Hi-Fi Products Service Bulletin

Model: CDP-67ES/C615

No. 260

Subject: Right Hand Side Segments of Display Light, Even When
The Power Is Off **Date:** March 20, 1992

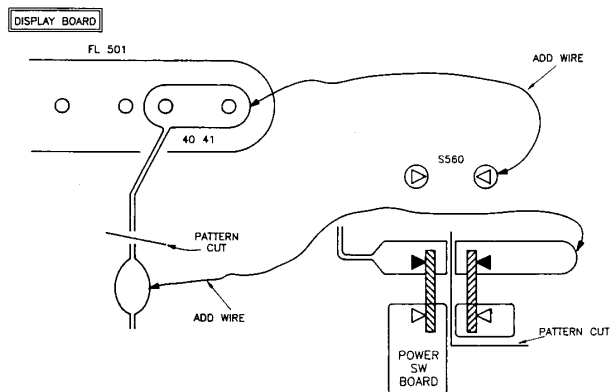
Symptom:
(13)

Right hand side segments of the display light, even when the power is off.

Perform the following modification:

1. Cut pattern off FL501 / pin 40 and 41 in the Display Board as shown.
2. Cut pattern off power switch S560 in the power SW Board as shown.
3. Add wire from power switch S560 to FL501 / Pin 41 as shown.
4. Add wire from power switch S560 to pattern as shown.
